MIDORI PRECISIONS CO.,LTD.

Process Change Notification

Model change of LP-50F series

September 30, 2014

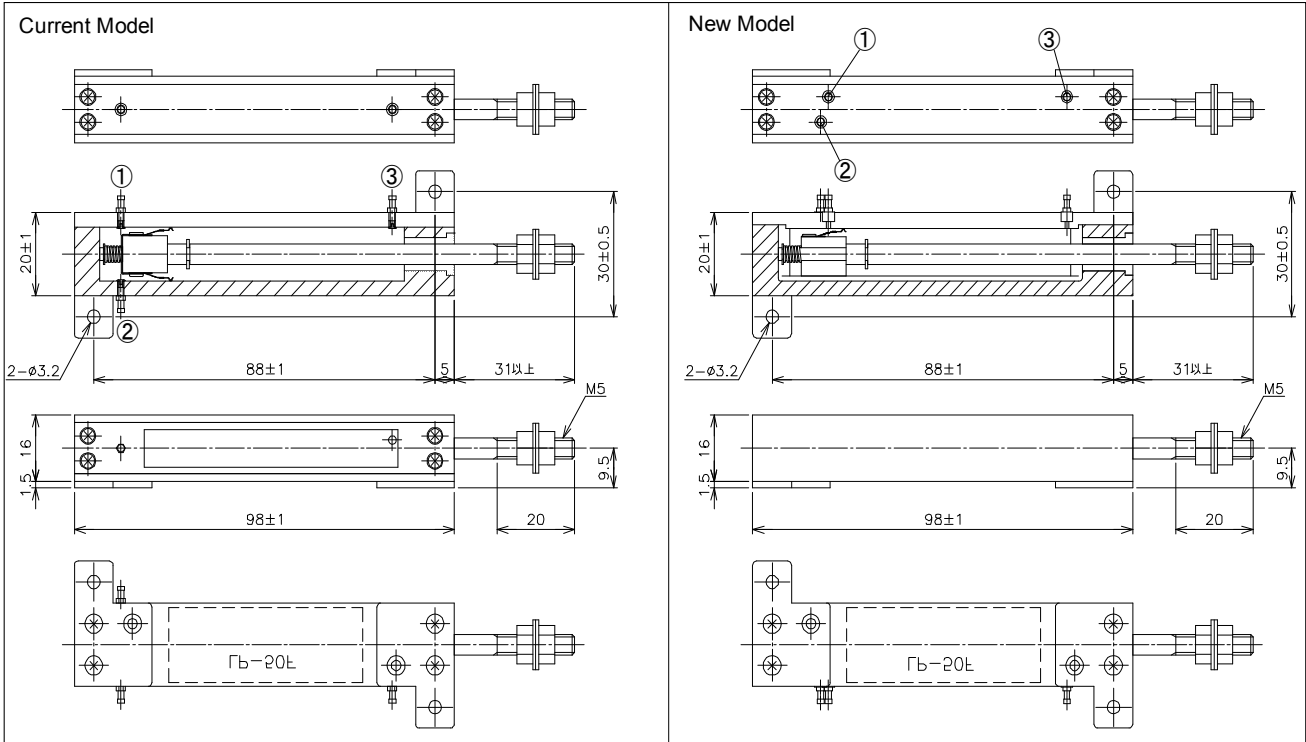
We introduce that LP-50F series will change Housing and Element from December 2014 production.

1. Housing material will be changed to Aluminum die casting and its surface anodized. (Color: Black)
2. Improvement in reliability of shaft play by changing slider and wiper design.
3. Collector part will be placed to element side. Then terminal pin will be changed.
4. Electrical and Mechanical specifications will not be changed.
5. Mounting positions will not be changed.
6. Resistance value : 500ohm will be discontinued. 10kohm will be added.
7. Shaft starting friction force will be changed. (ex. LP-50FB: from 0.4N approx. to 0.8N approx.)
